31/07-0417 2801 Beechbank Rd  
Capitol View Park Historic District

HPC Staff copy

SPECIMEN TREE SURVEY - ARBOR HOMES  
 BEECHBANK ROAD, SILVER SPRING, MARYLAND  
 Prepared by: Keith C. Pridford, ISA Cert. Arborist, MA-0176

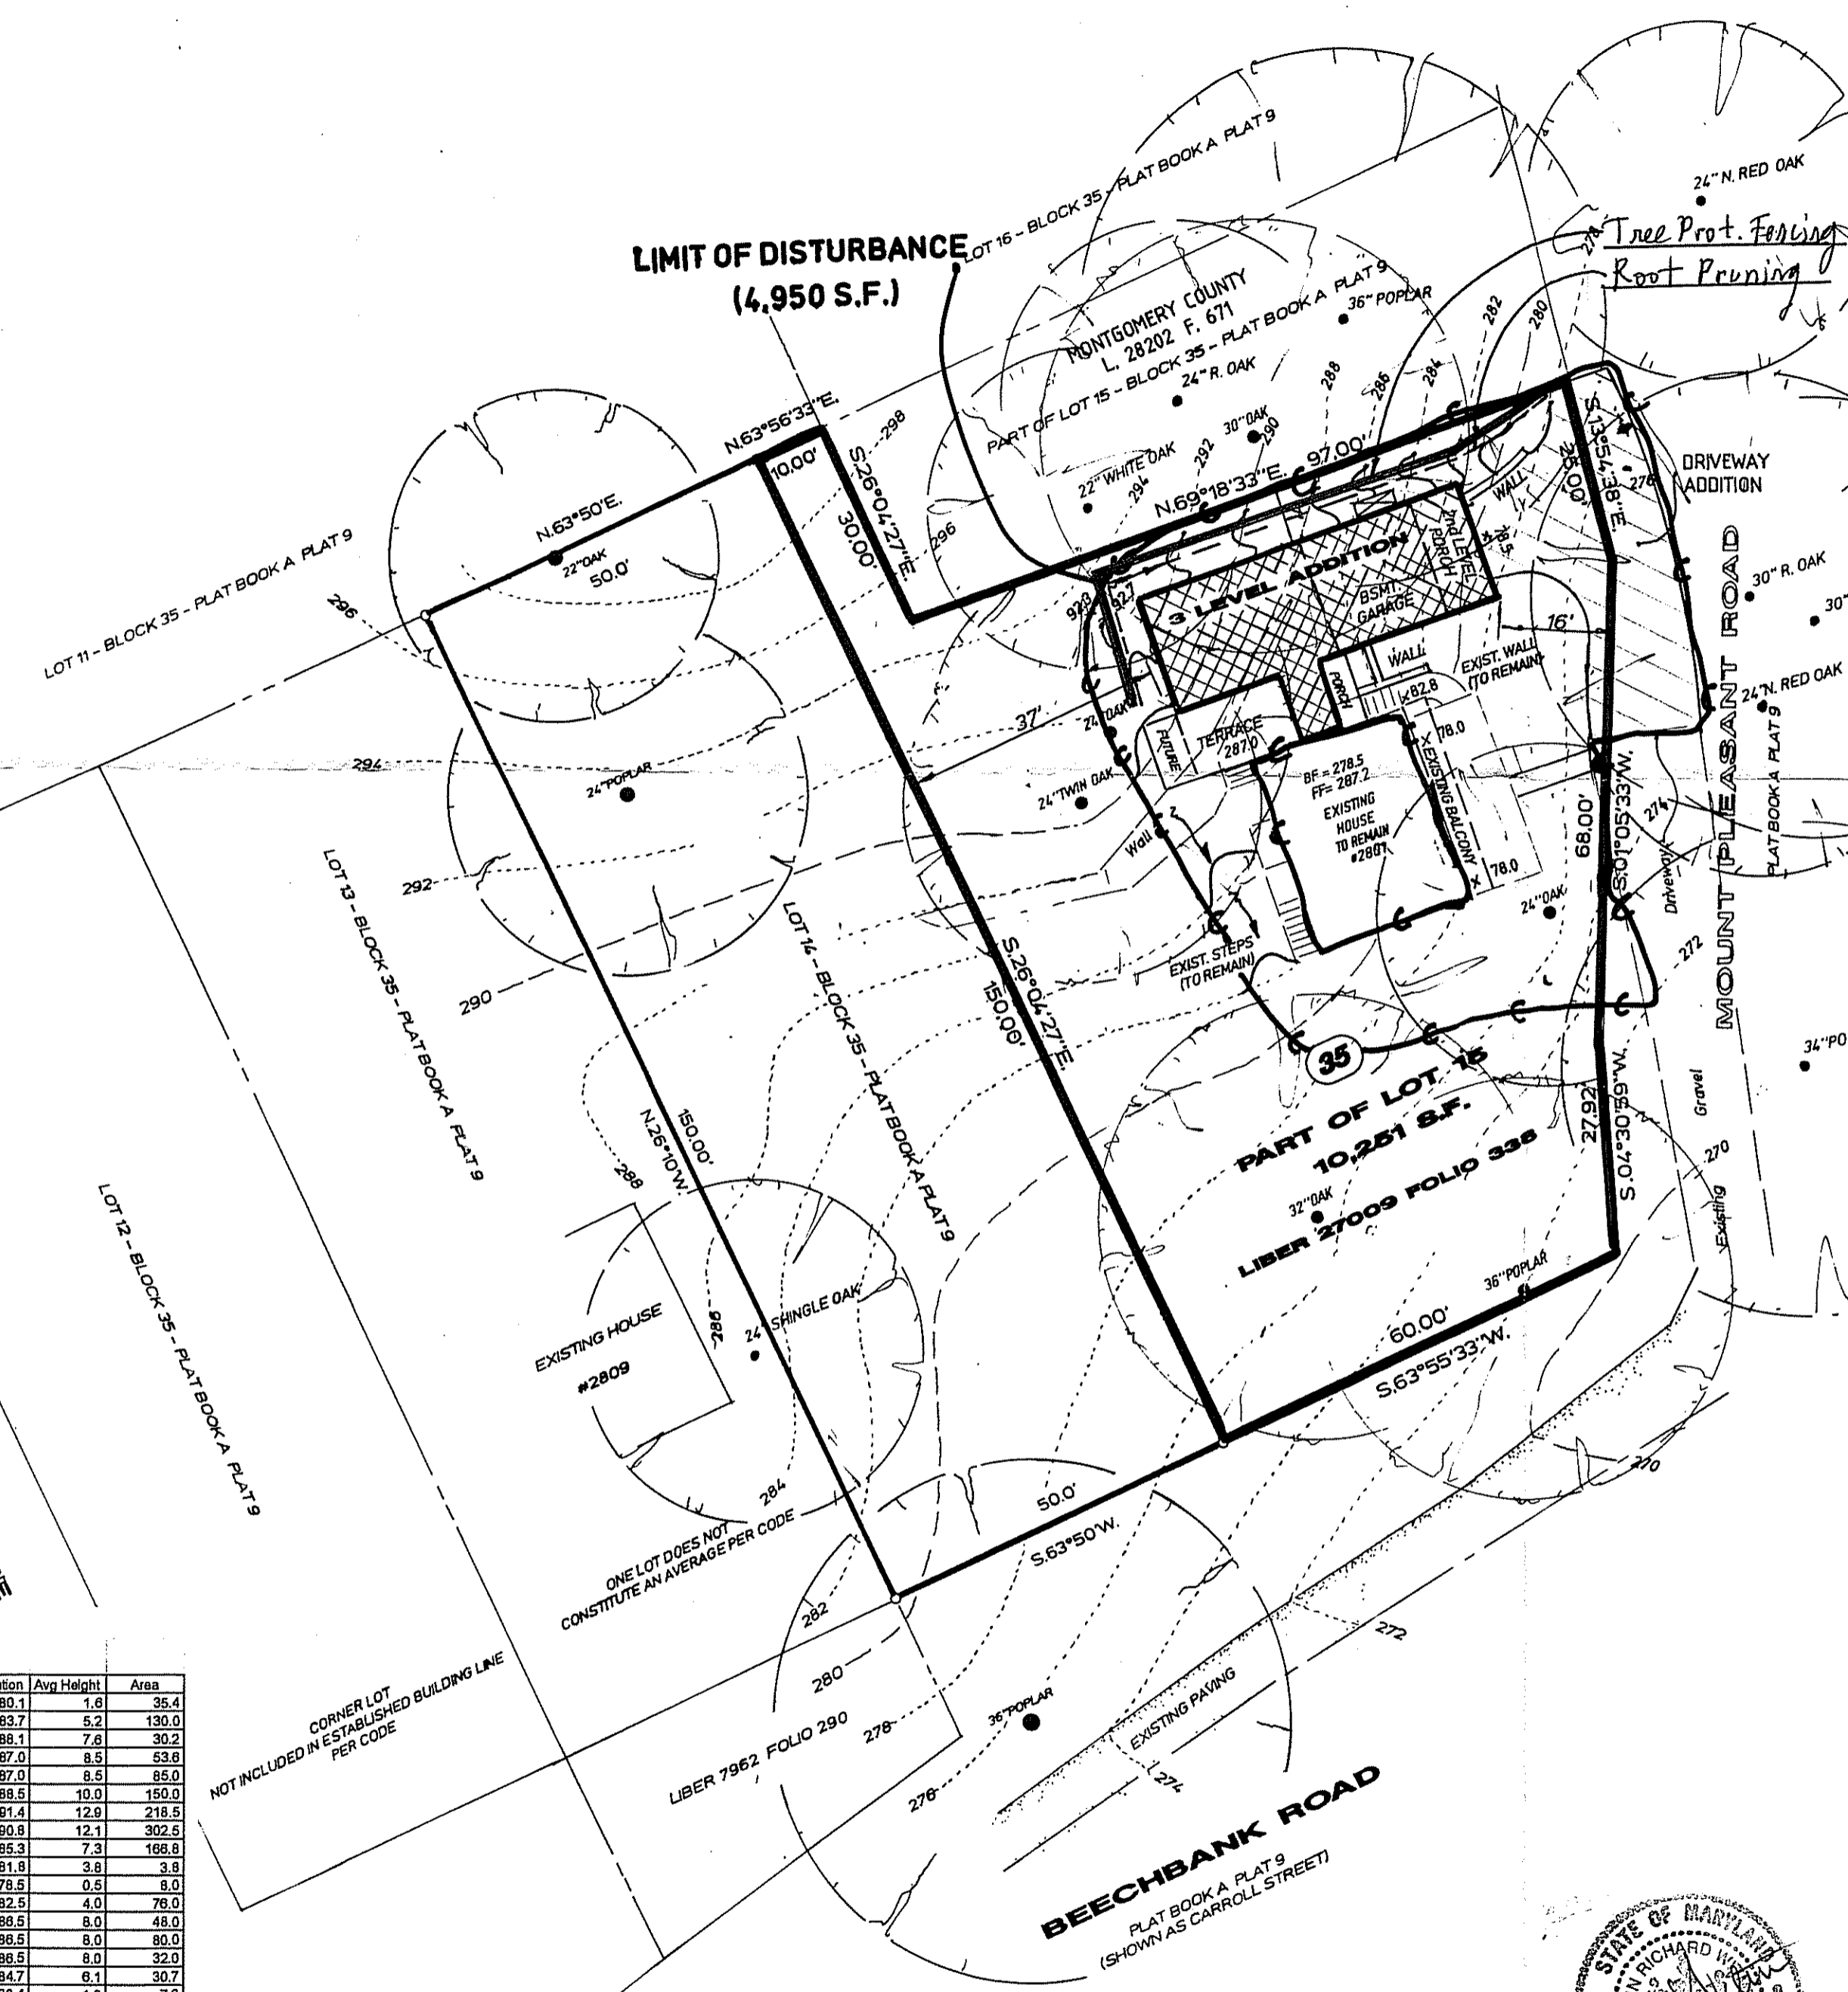
I recently revisited your property at 2801 Beechbank Road in order to survey several of the large trees around the existing home. I brought the newest site plan for this property so that I could get a feel for the potential impacts to these trees

Your site plan shows root pruning at approximately 12' from the base of this tree. This is within the area around the tree which is termed the minimum clearance zone (MCZ). This is a zone with a radial distance equal to 6" for each inch of dbh. So, for this tree the MCZ would be 18.5'. Within this zone are found the large, woody scaffold roots which are responsible for the structural stability of the tree, as well as being the basis of the entire absorbing root system. It is always advisable to avoid cutting these roots.

I am also concerned with the long-term prognosis for the large, double-stemmed White oak (*Quercus alba*) to the left of the existing house. There has already experienced quite a bit of root damage from the digging done near the base in the recent past. There are some severed roots which are now exposed. These should be pruned and then buried to prevent drying. I would also recommend the Cambistat and borer control treatments for this tree as well *tree #14*

I feel that these are the highest priority tree care items on your site at this time. There are other tree care needs to attend to on the property, but these are the most important. Please call me with any other questions you may have. At a later date, we can discuss the needs of the remaining large trees on the property.

PROPOSED  
SITE PLAN

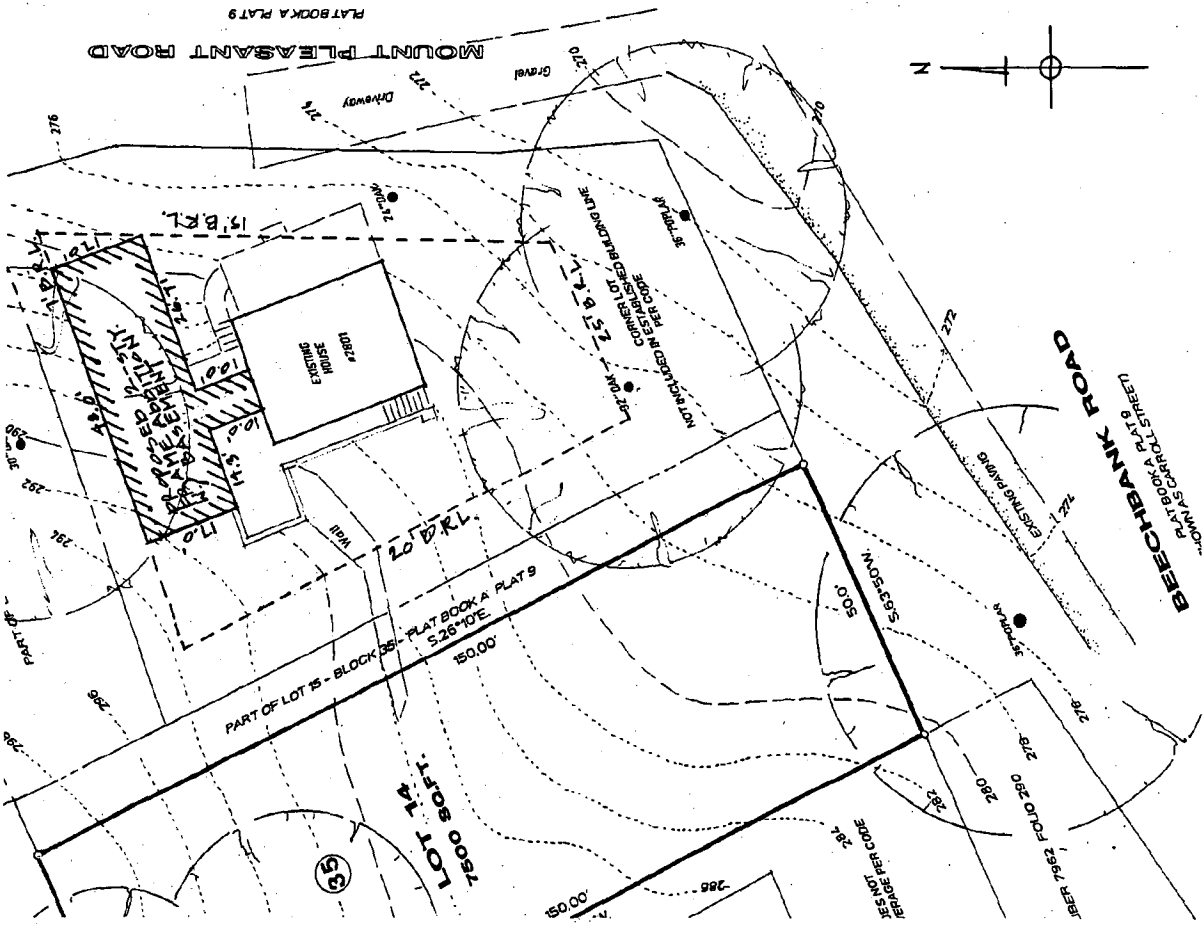
1. The addition must be reduced in size so that it does not exceed the western plane of the existing house.

2. The terrace and pergola will be reduced in size so that it does not exceed beyond the western plane of the existing stairwell.

The addition has been reduced in length by 6' since the last HAWP submittal. However, staff continues to encourage a design for the addition that does not project beyond the western plane of the existing house. The current proposed addition is 8' beyond the western plane of the existing house. Additionally, the proposed terrace with pergola projects an additional 6' beyond this addition. Therefore, staff recommends that the Commission support this proposal with the condition that the western extension of the addition not exceed the western plane of the existing house and that the terrace and pergola not exceed beyond the western plane of the existing stairwell.
